Project	IEEE 802.16 Broadband Wireless Access Working Group < http://ieee802.org/16 >	
Title	Relay Station Handover Procedure	
Date Submitted	2007-03-12	
Source(s)	Hang Zhang, Peiyong Zhu, Mo-Han Fong, Wen Tong, David Steer, Gamini Senarath, Derek Yu, Mark Naden, G.Q. Wang Nortel 3500 Carling Avenue Ottawa, Ontario K2H 8E9	Voice: +1 613 7631315 [mailto:WenTong@nortel.com] [mailto:pyzhu@nortel.com]
Re:	A response to a Call for Technical Proposal, http://www.ieee802.org/16/relay/docs/80216j-07_007r2.pdf	
Abstract	This contribution proposes RS handover procedure which is required when an RS migrates from the air-interface provided by one access station to the air-interface provided by another access station due to radio environment change or topology change, etc.	
Purpose	To incorporate the proposed text into the P802.16j Baseline Document (IEEE 802.16j-06/026r2)	
Notice	This document has been prepared to assist IEEE 802.16. It is offered as a basis for discussion and is not binding on the contributing individual(s) or organization(s). The material in this document is subject to change in form and content after further study. The contributor(s) reserve(s) the right to add, amend or wi

Figure XXX. RS HO process

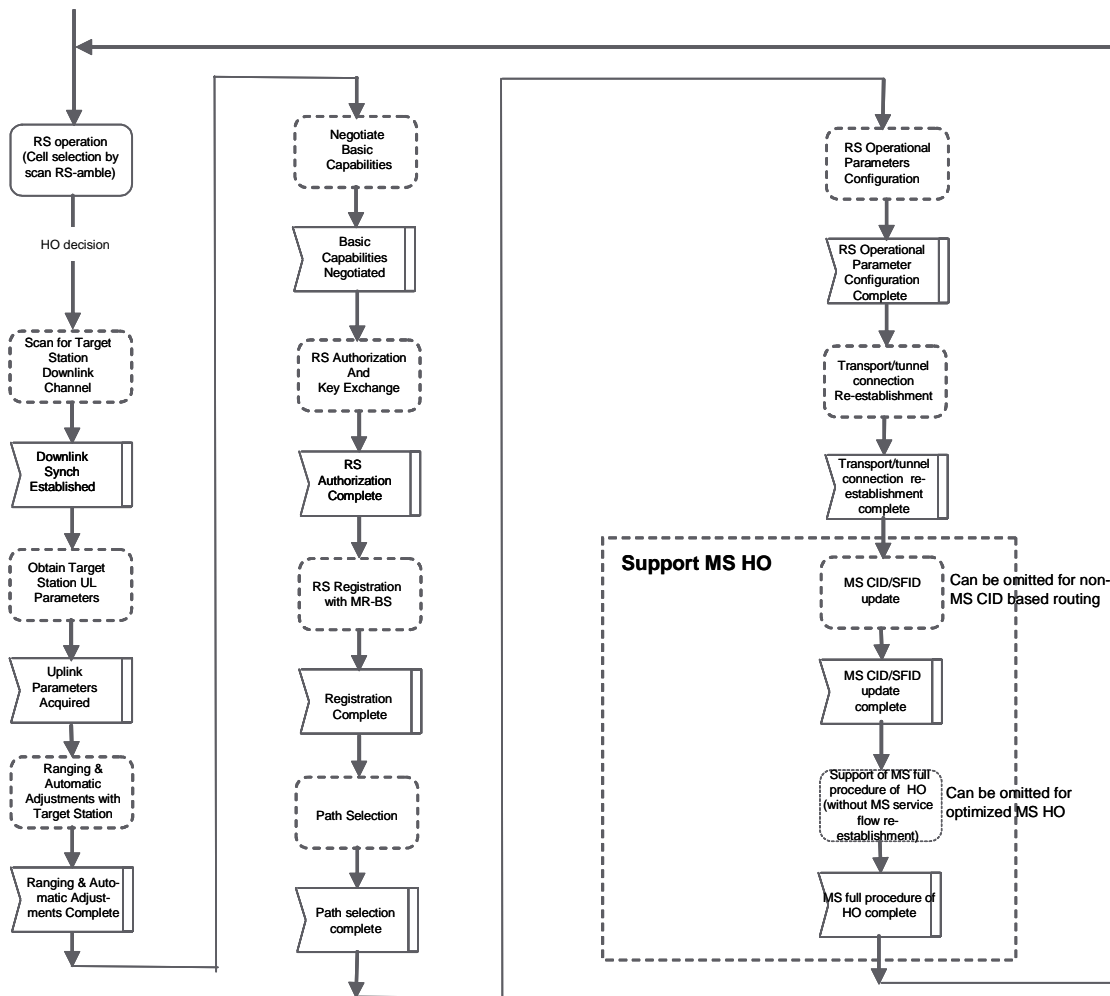
[Replace section 6.3.22.4 with the following]

This section defines the RS HO process in which an RS migrates from the air-interface provided by one access station to the air-interface provided by another access station. The RS HO process is depicted in Figure xxx.

The RS HO process consists of stages of MS HO process and following additional stages

- Path selection – This stage enable the target MR-BS to indicate a path re-reselection. The target MR-BS may decide to skip this step if the bit #0 in RS HO optimization TLV of MOB_BS_RSP/REQ is set

- RS operational parameter configuration – This stage enable the target MR-BS to reconfigure RS operational parameters. The target MR-BS may decide to skip tis step if the bit #1 in RS HO optimization TLV of MOB_BS_RSP/REQ is set

- Tunnel/connection re-establishment – this stage enable the target MR-BS to re-establish connection/tunnel for a RS. The target MR-BS may decide to skip this step if the bit #2 in RS HO optimization TLV of MOB_BS_RSP/REQ is set

- Support of MS HO stage is not required for RS in MBS mode and needed only for RS in MRS mode. This stage includes two sub-stages:
 - o Support of MS service flow re-establishment – This step is required only if MS CID based data forward is in use. In this case, this stage is used for the target MR-BS to inform the requesting RS regarding the CID/SFID updates of associated MSs/RS. For non-MS CID based data forwarding schemes, this step can be omitted. In this case, there is no MS CID/SFID is required. Since for DL data packet forwarding after the RS HO, the MR-BS can route the DL data packet of MSs associated with the RS to the tunnel/basic connection of this RS and no MS CID collision would happen.

- o Support full set of MS HO – This sub-stage can be omitted if optimized HO is possible. For non-optimized MS HO, the MS service flow re-establishment can always be omitted for non-MS CID based routing; for MS CID based forwarding, the RS may use CID swapping to avoid involvement of MS regarding the MS service flow re-establishment.
